SUPPLEMENT 1
EDGEMONT URANIUM MILL DECOMMISSIONING PLAN
ENVIRONMENTAL REPORT

Tennessee Valley Authority Responses
to
Nuclear Regulatory Commission Questions
on
Edgemont Uranium Mill Decommissioning Plan
Environmental Report

Questions Forwarded By
Letter From Ross A. Scarano To
L. M. Mills, Dated November 21, 1979

January 1980

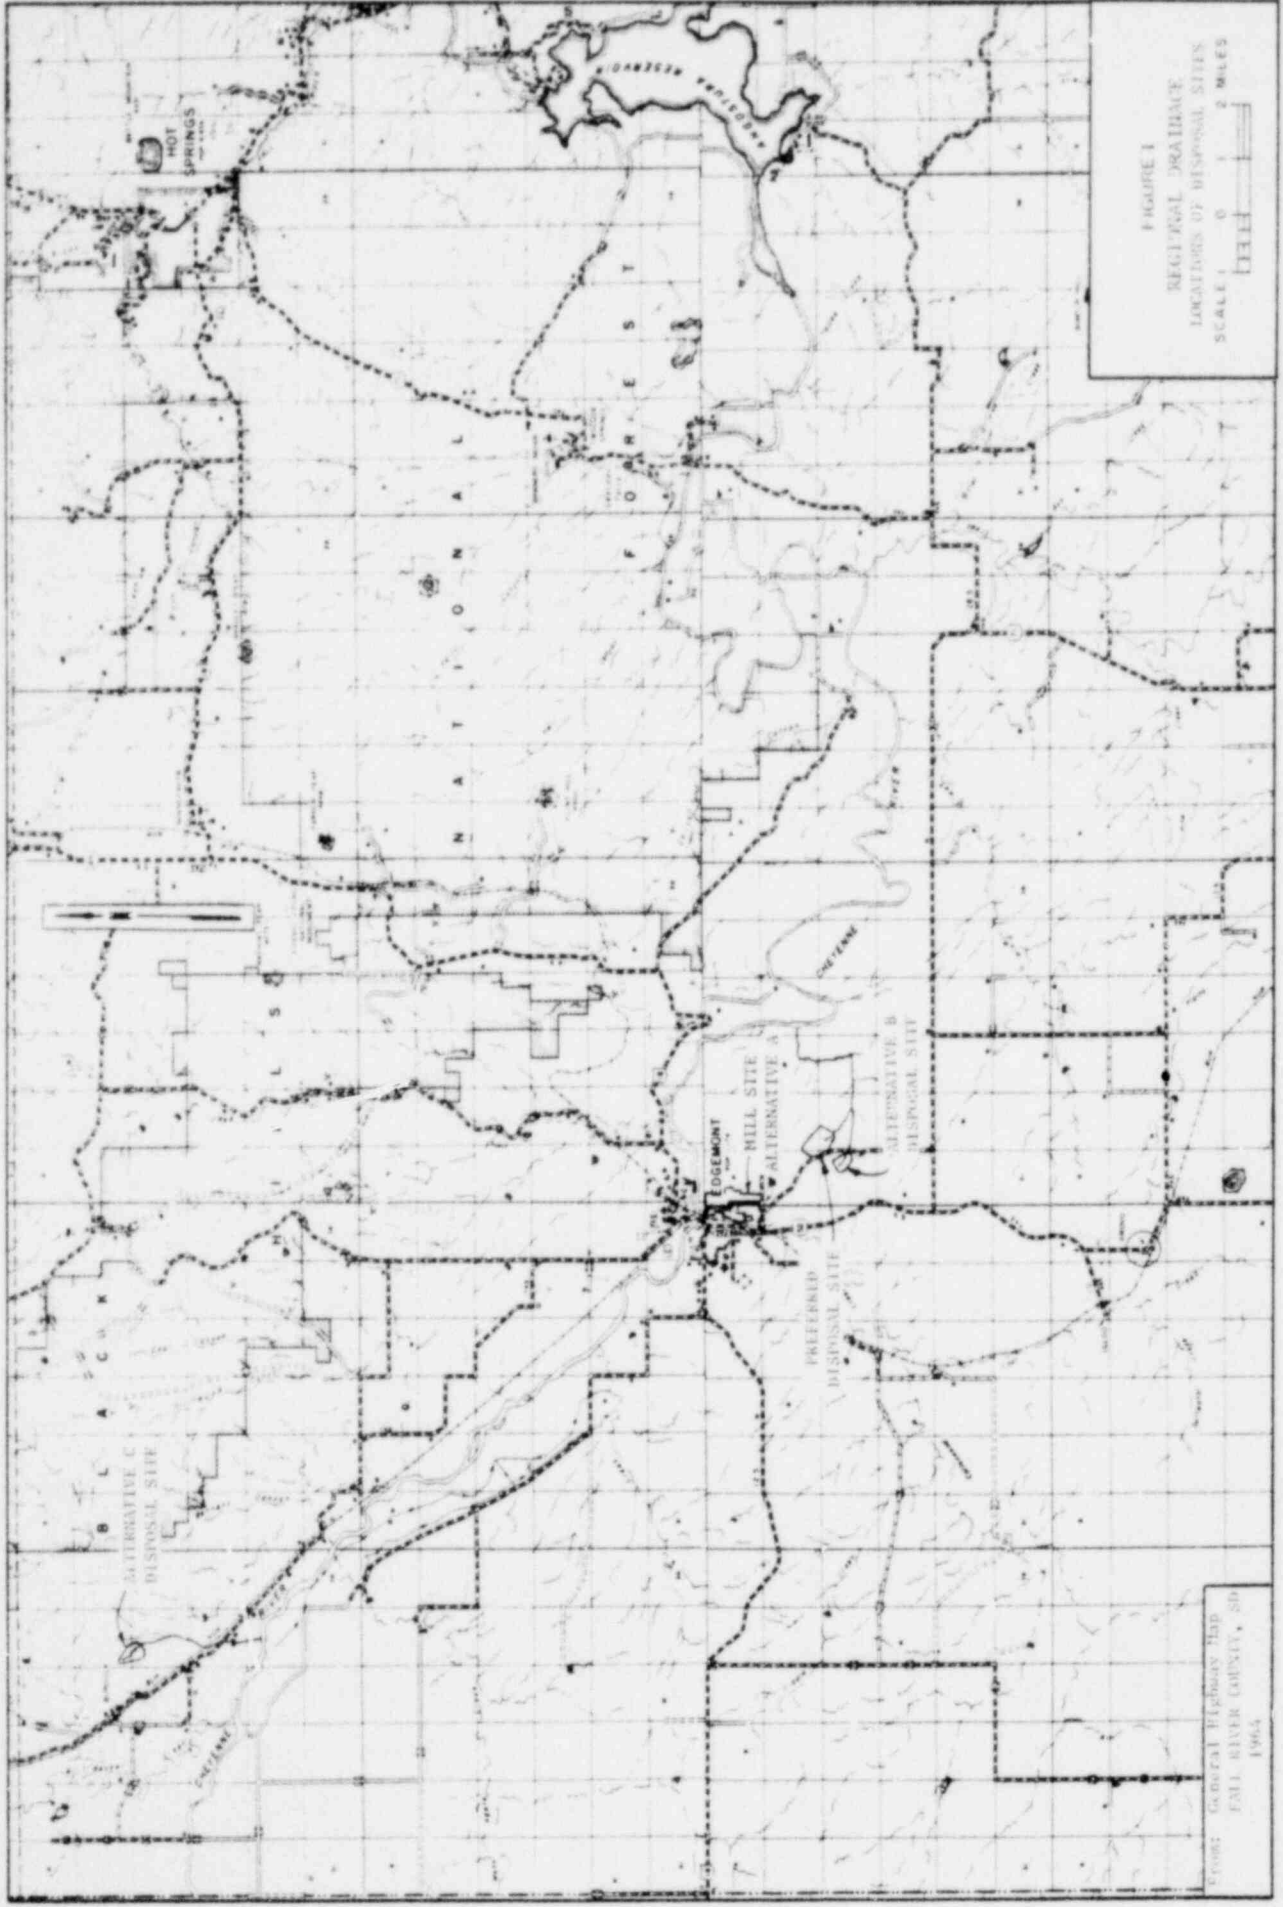
Figure 4.2-1 is difficult to read. The applicant should provide a clear surface water map of the area specifically identifying locations of preferred and alternate sites and potentially effected water bodies.

A regional map showing surface water features and disposal site locations is provided in Figure 1, attached. Figure 4.2-6 of the ER shows general locations of the sites with respect to the Cheyenne River. ER Figures 4.2-1, 4.2-2, 6.2-1, and 6.2-2 show the detailed drainage at each site and are reproductions of available topographic maps.

FIGURE 2
EDGEMONT MILL SITE
SURFACE WATER FEATURES

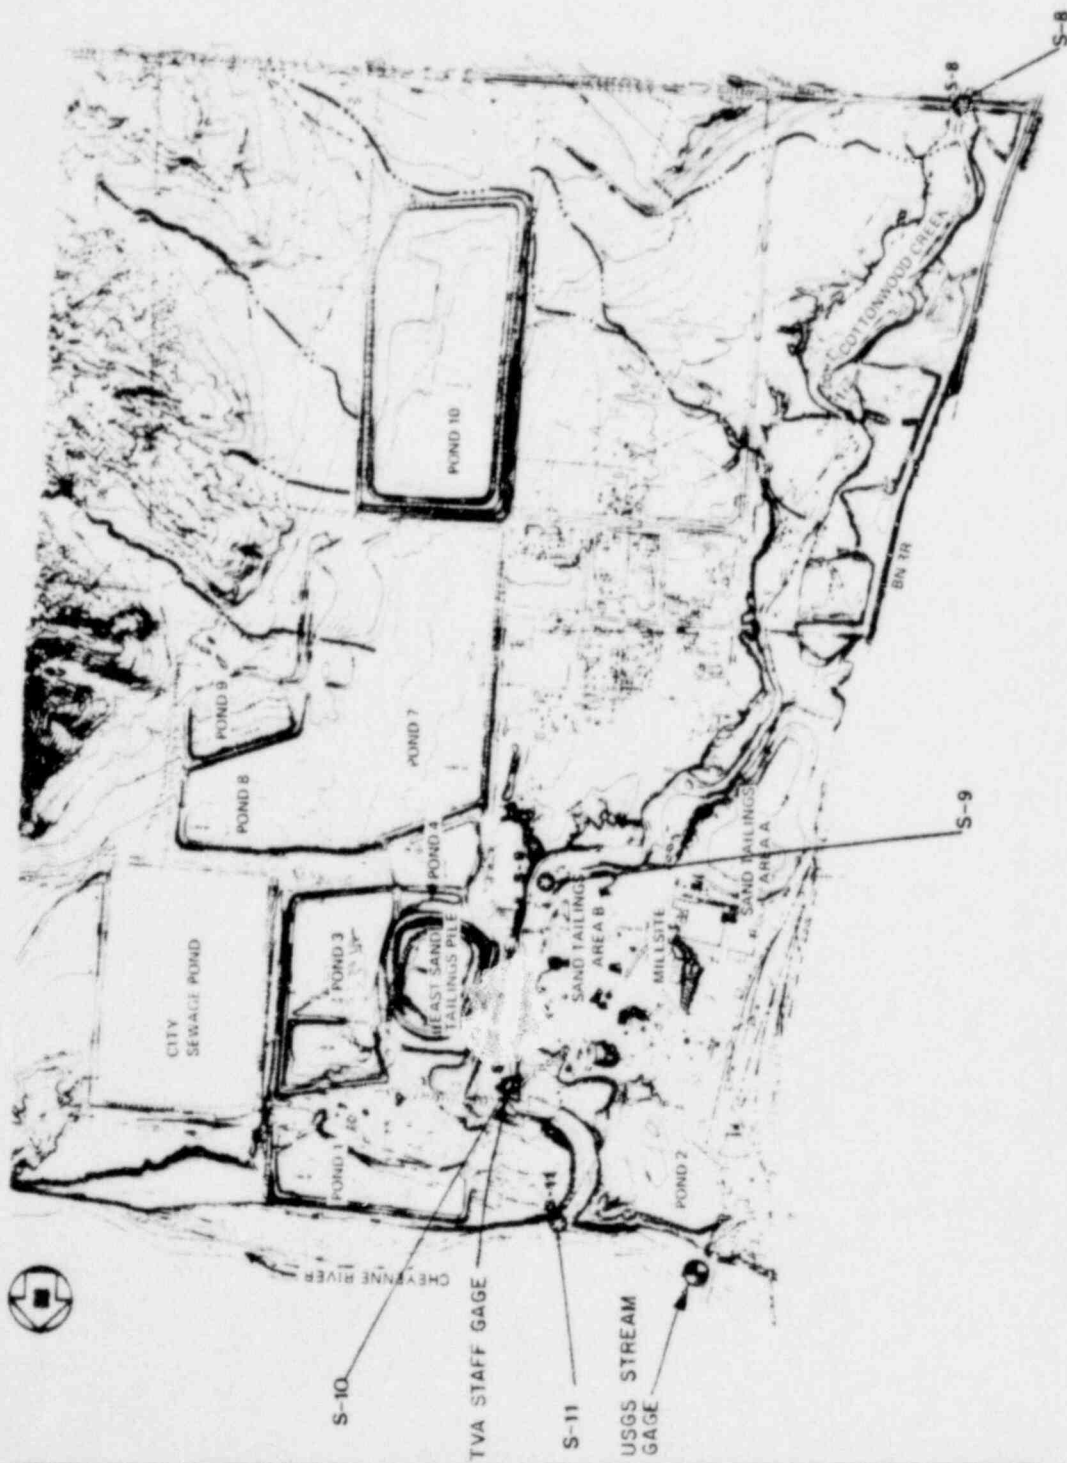
Figure 4.2-2 location and identification of water quality monitoring sites should be clearly indicated on the map.

The figure (see attached Figure 2) has been modified slightly to improve the clarity of the water quality monitoring stations.

Station S-8 was inadvertently omitted from ER Figure 4.2-2.

VEGETATIVE ASSOCIATION MAP FOR ALTERNATIVE DISPOSAL SITE NO. 8

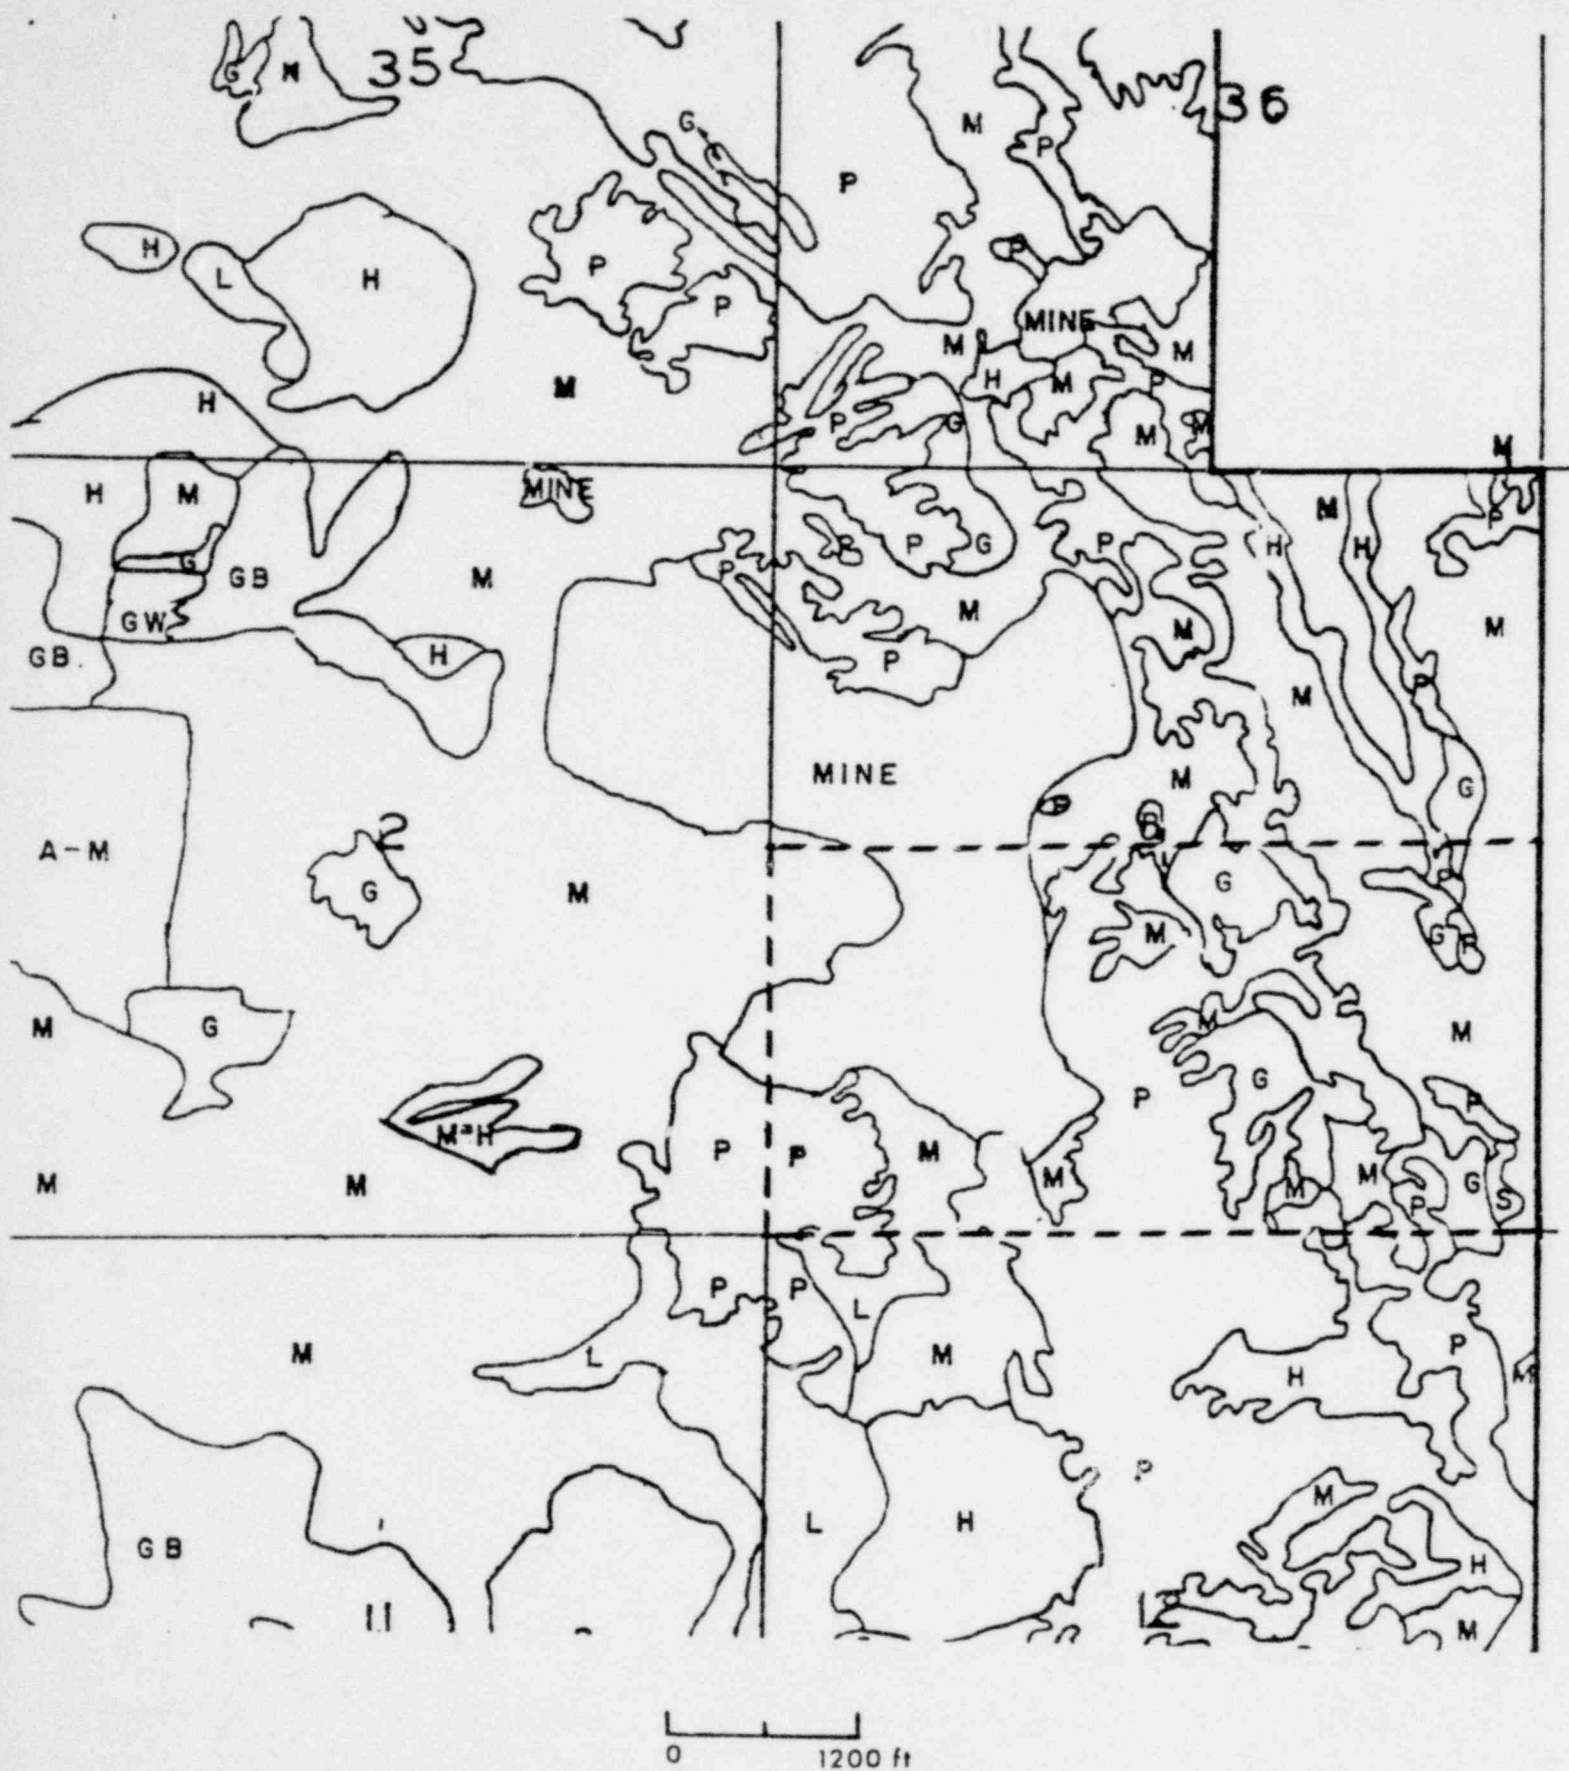
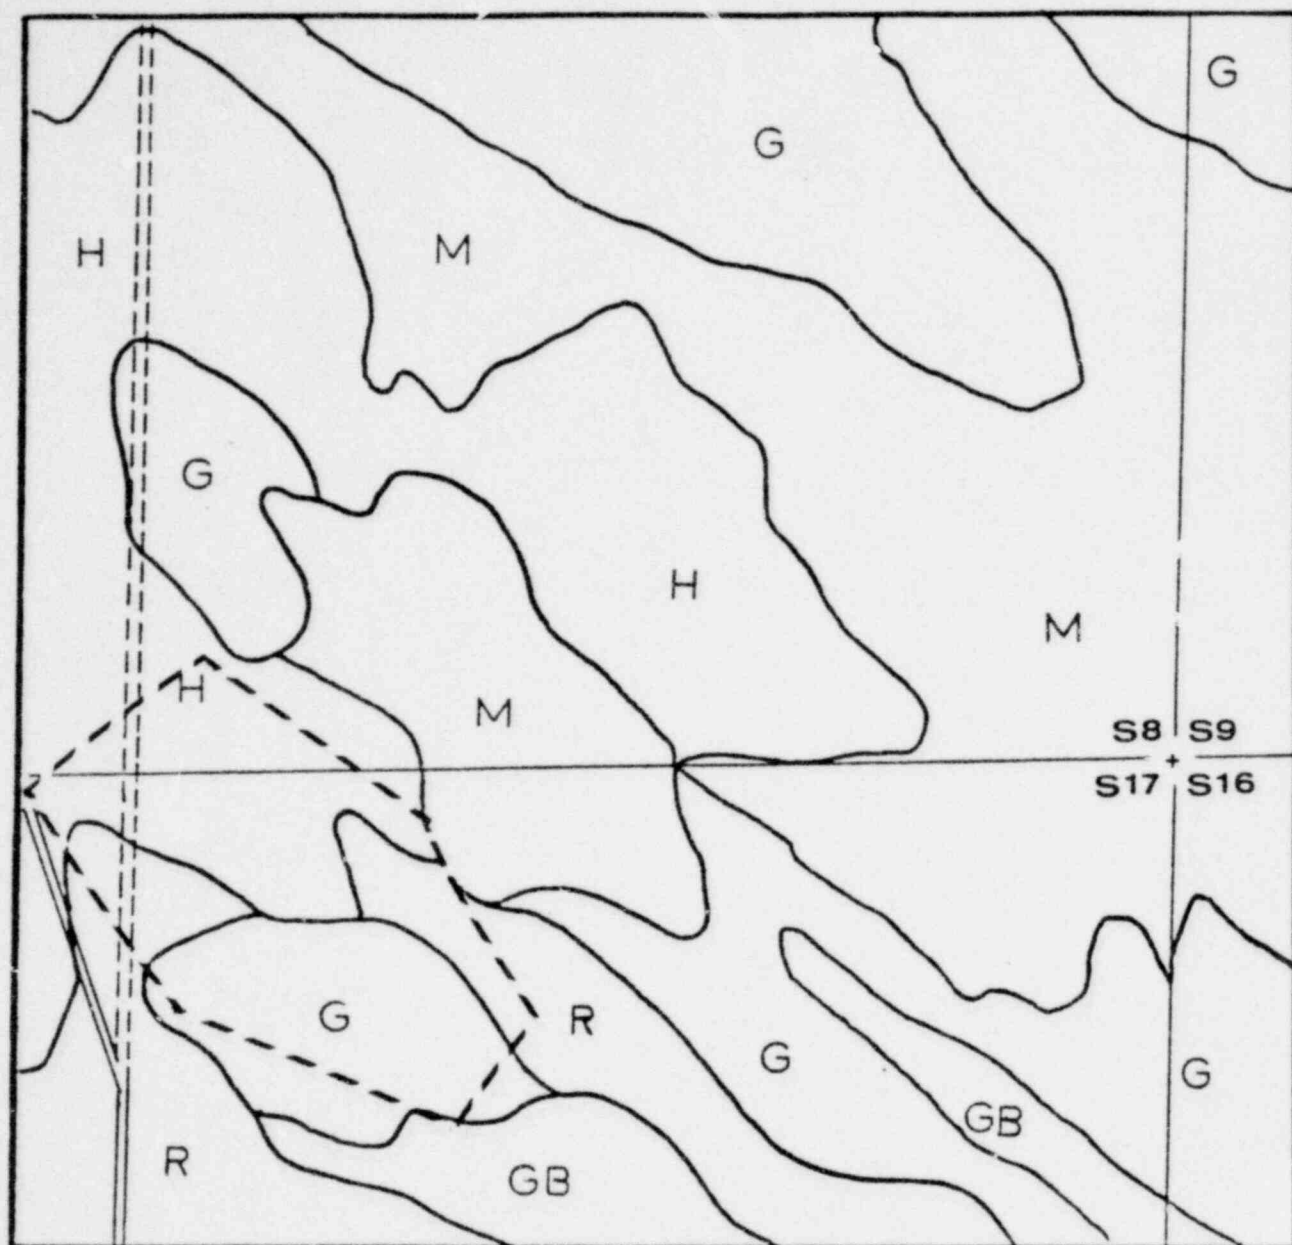
Please provide a map depicting the distribution of the principal plant communities of the project area including alternate disposal sites.

Maps showing the distribution of the principal plant communities of the preferred site and site 8 are provided in Attachment 3. (7)
